Meeting Name: Planning & Zoning Board Meeting
Meeting Date: July 15, 2024
Prepared By: Isabella Hickey
Item Title: Application for a Major Development and Site Plan Amendment to the 700 Ocean Drive Planned Unit Development (Recommendation to Town Council)

704 Ocean Drive (Inspiration home)

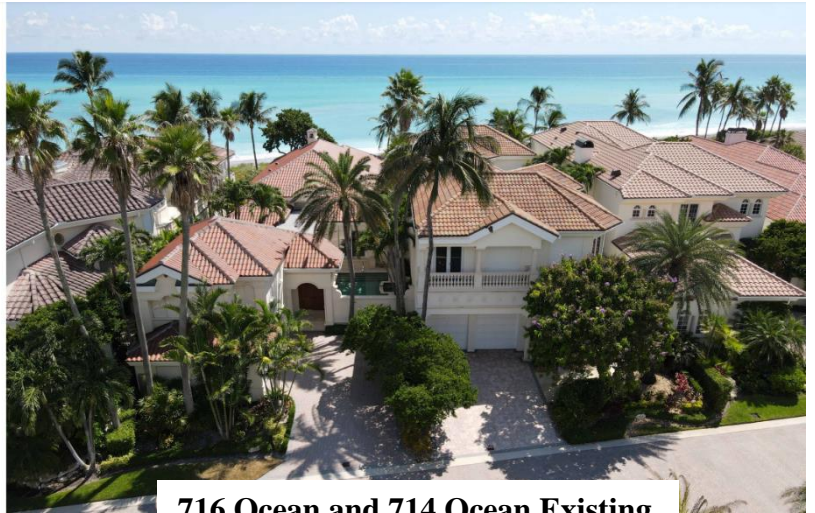
Applicant's Response: Style: The style of the proposed home is keeping with the Old Florida style that consists of the Key West Cracker Coastal and Mediterranean Vernacular. The subdivision is more of the Mediterranean style, as per the original construction in the 1990s. Within the last 10 years, homes have been updated in the neighborhood to transform the style into a mixture of both Mediterranean and Key West Cracker Coastal, such as 704 Ocean Drive (pictures below). This new construction at 714-716 Ocean Drive will mimic this style and combine Mediterranean and Key West Cracker Coastal. The construction of this home will be concrete masonry block and smooth stucco. The roof construction will be simple pitched roof trusses with a barrel pink-reddish concrete tile to match the roofs of the existing 700 Ocean Drive residences in the community. The body will be a similar light crème color as 704 Ocean Drive.

The elevations consist of some Florida Vernacular design elements such as the large lantern lights, large patio spaces, balconies, lush landscaping, and louvered/paneled garage doors just as 704 Ocean Drive did to update the home around 2017. The rear will feature an abundance of glass to capture the ocean view and feeling of outdoor living.

Please see picture to the right of 704 Ocean Drive, as the inspiration for the new home.
